Planning and Zoning Commission

September 1, 2020

TO: Planning and Zoning Commission
FROM: Evann Martin, Assistant Planner
DATE: September 1, 2020
RE: Prairie Business Park Parking Expansion – Site Plan Amendment

RE: Prairie Business Park Parking Expansion Site Plan

1 SW-513 INTAKE WITH STANDPIPE - POND 1 OUTLET
NOT TO SCALE

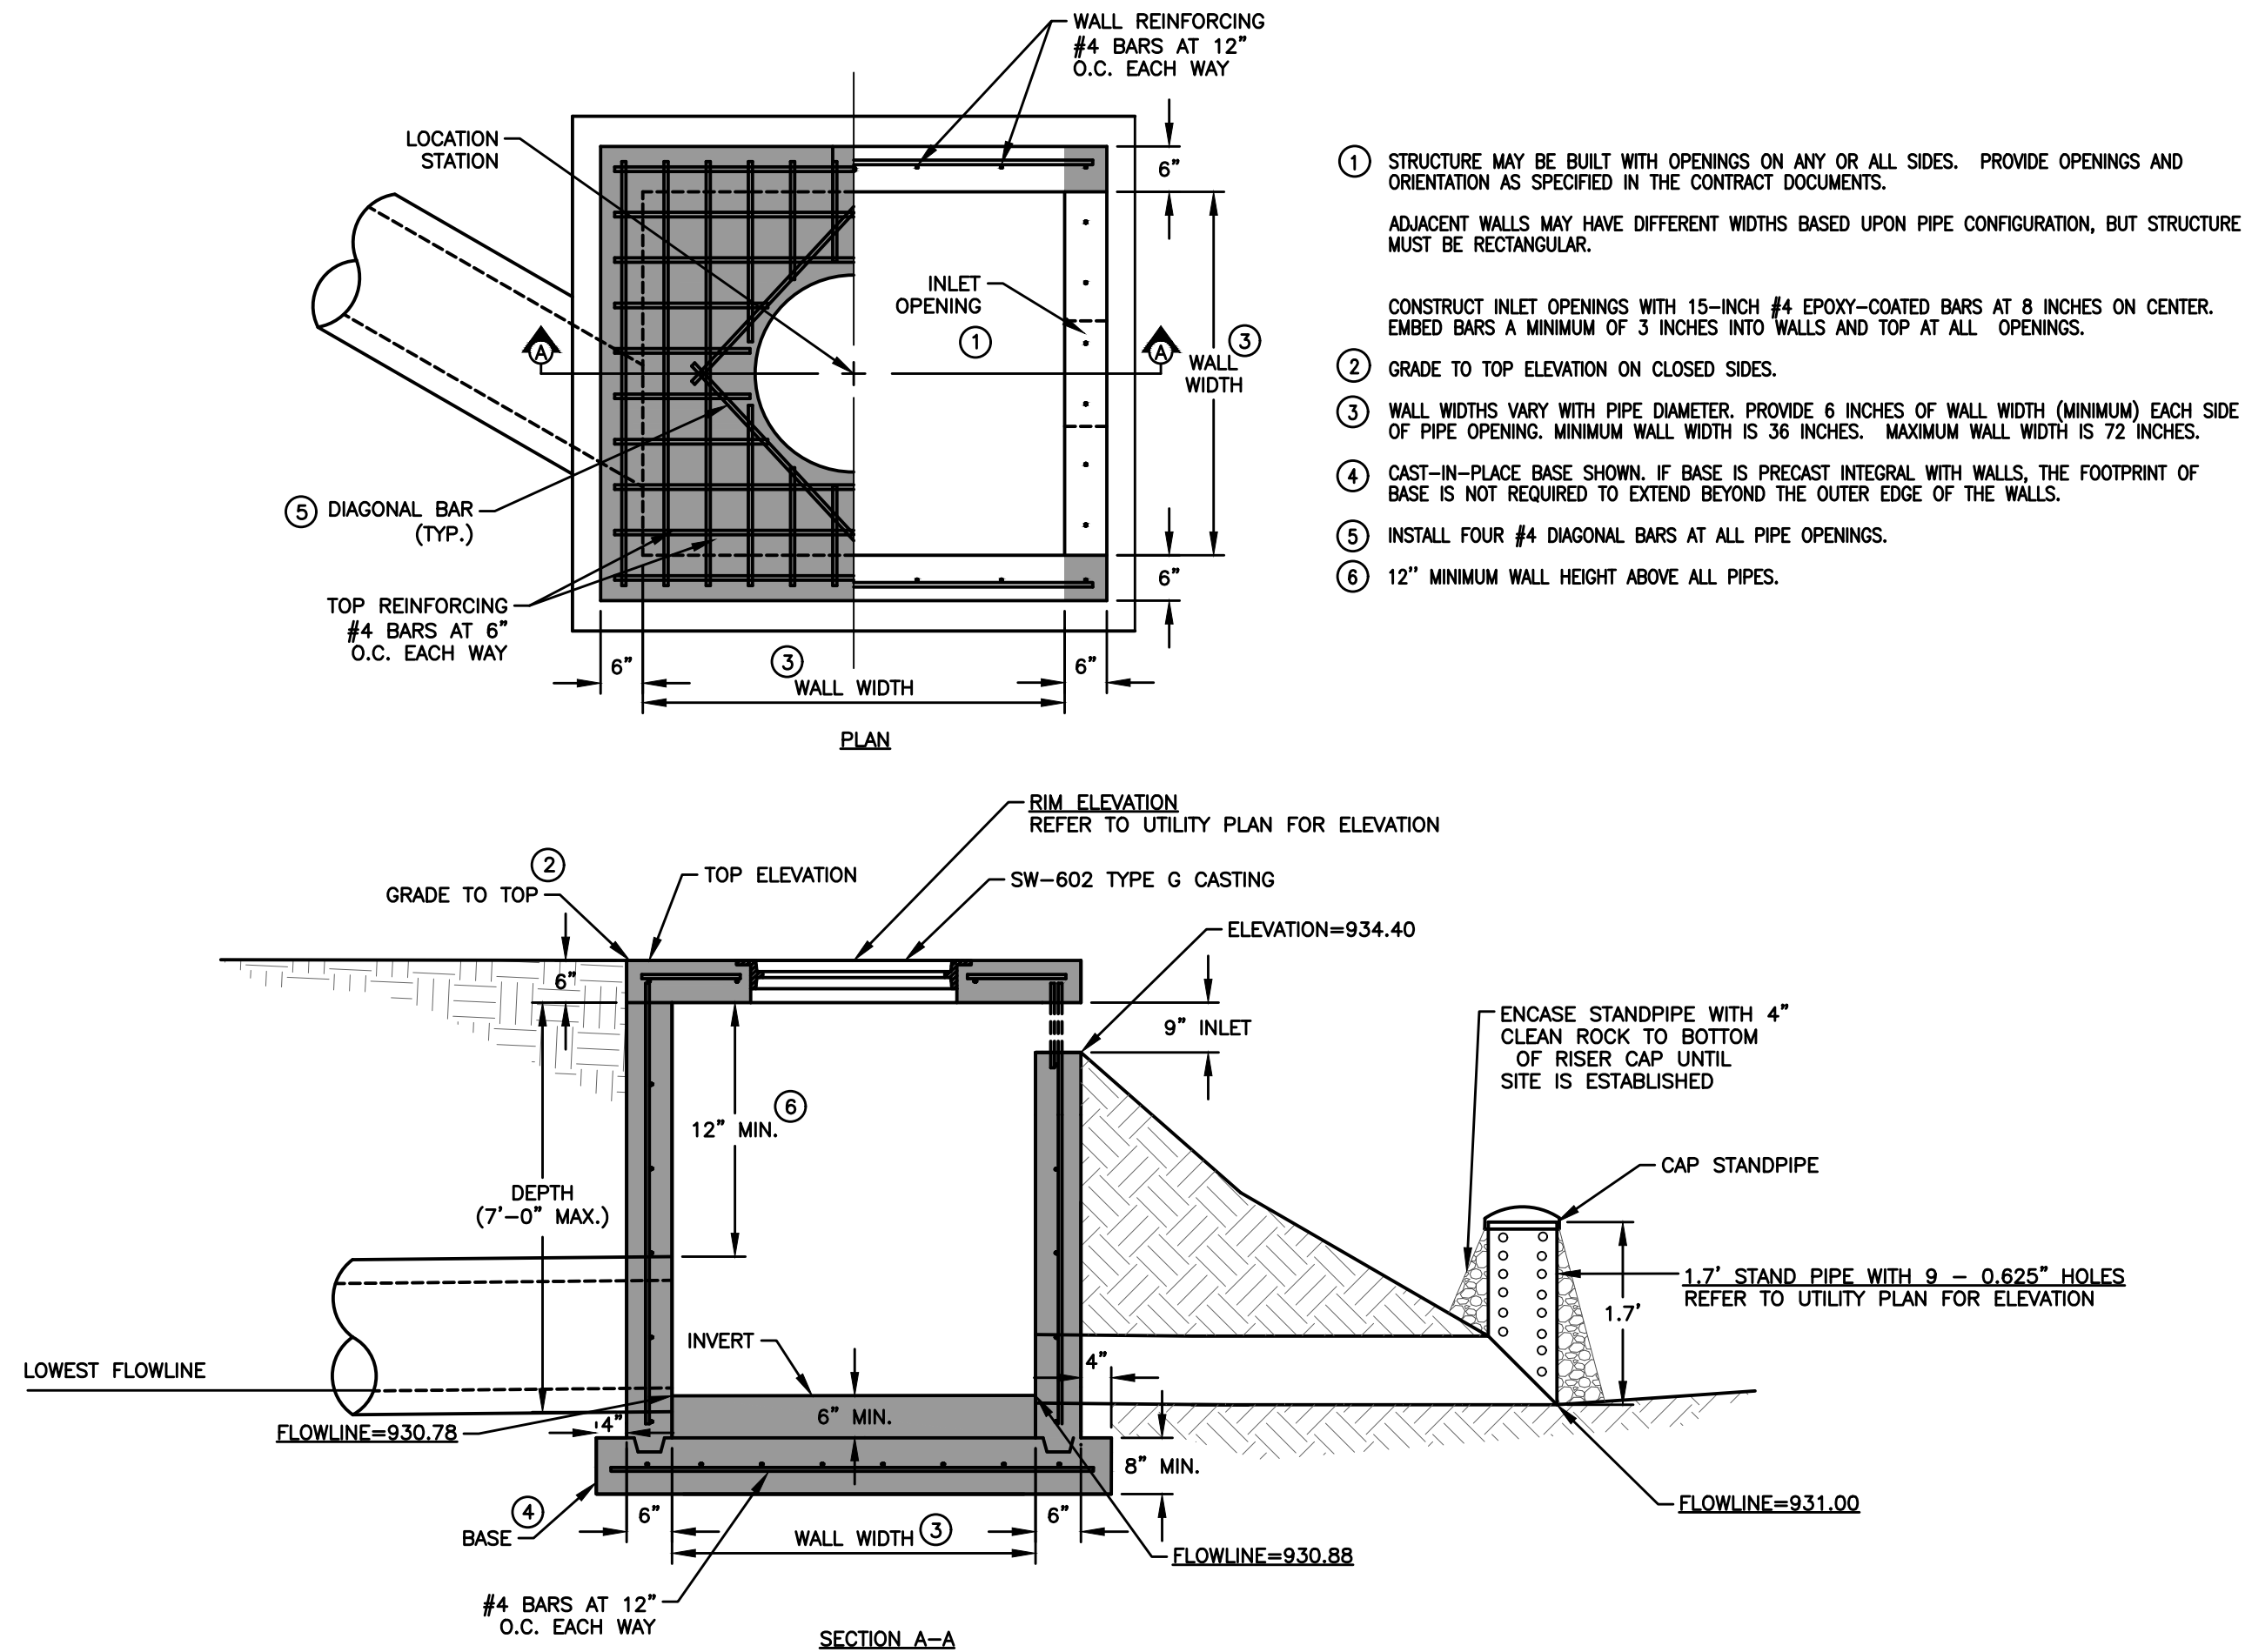
12. ~~Page 7/8: For Detail 11, demonstrate all on-site water, including water from DA1, is channeled through the internal standpipe prior to exiting through pipe #1A. Not enough detail provided. Perhaps a plan view would be helpful.~~

15. Page 7/8: The response “Plate has been added to ensure stormwater entering the intake does not flow directly into the open top of the standpipe” did not address the comment. For Detail 11, demonstrate all on-site water, including water from DA1, is channeled through the internal standpipe prior to exiting through pipe #1A. Not enough detail is provided. Perhaps a plan view would be helpful.
